WESTWINDS
995.31 ACRE TRACT

MASTER DEVELOPMENT PLAN AMENDMENT 808-E

Re: Westwinds Master Development Plan **MDP # 808-E**

The City Staff Development Review Committee has reviewed the Westwinds Master Development Plan **M.D.P. # 808-E** and approved. Please note the following:

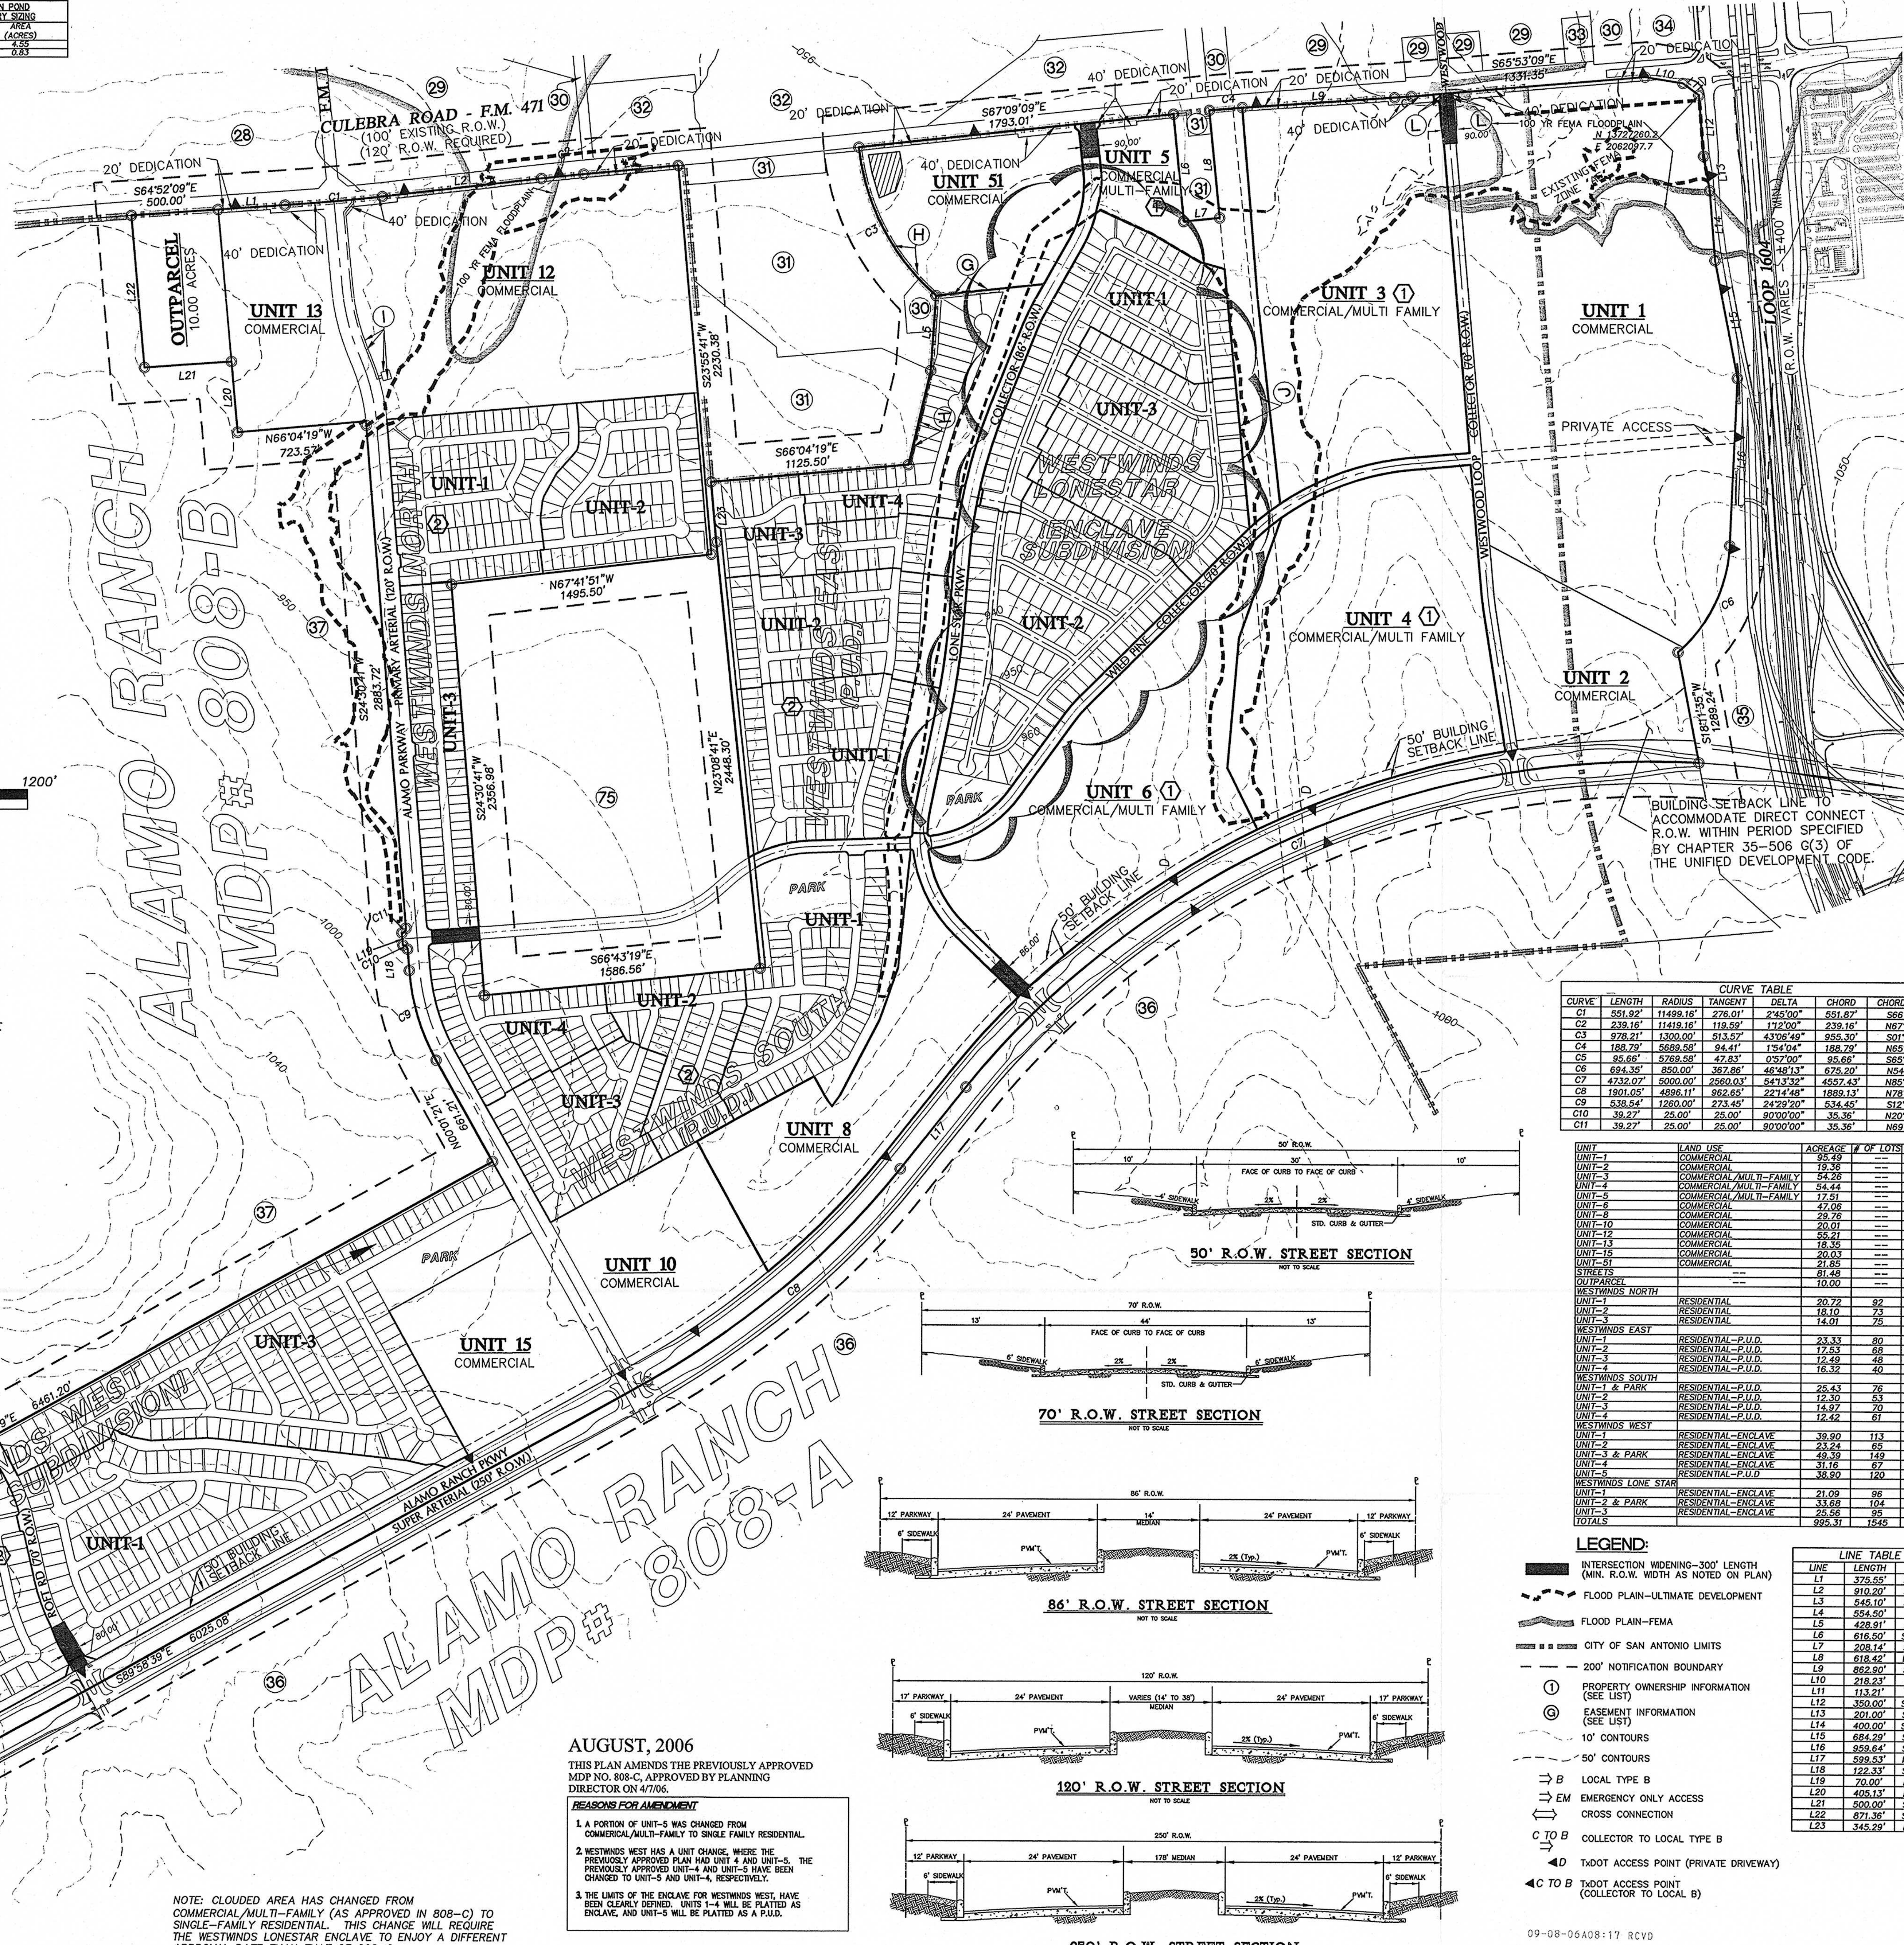
In consideration of public safety and convenience, excessive grades by reason of topography should be avoided in street layouts and arrangements.

Any access and R.O.W. issues along state facilities will need to be resolved with the **Texas Department of Transportation (TXDOT)**. For information about these requirements you can contact TXDOT at 615-5814.

DSD – Traffic Impact Analysis & Streets indicate that under the UDC listed below are some of the requirements and onsite improvements that are necessary and shall be provided by the developer, on and before the completion of the Westwinds MDP, at no cost to the City of San Antonio:

- All roadways shall follow Table 506-7, Functional Classification System Description and shall comply with UDC 35-502(a)(9)
- All sidewalks shall comply with UDC 35-506(q)
- Driveway throat lengths shall comply with UDC 35-506, Table 506-7
- All access driveways shall comply with UDC 35-506(r)
- Right turn and left turn lanes will be required at the two entrances

Parks recommends approval with the following conditions:

- The multi-family portions of this development will need to submit detailed plans at time of platting in order to determine their park dedication requirement.
- The Park/Open Space is to be dedicated to their respective Home Owners Associations and a Provision and Maintenance plan shall be submitted to this department at time of platting.
- The areas to be dedicated shall be labeled as either "Park" or "Open Space" at the time of platting.

The property must be platted in accordance to the UDC and the Major Thoroughfare Plan to reflect the approved MDP. It is suggested to work closely with the school district, so they can plan accordingly.
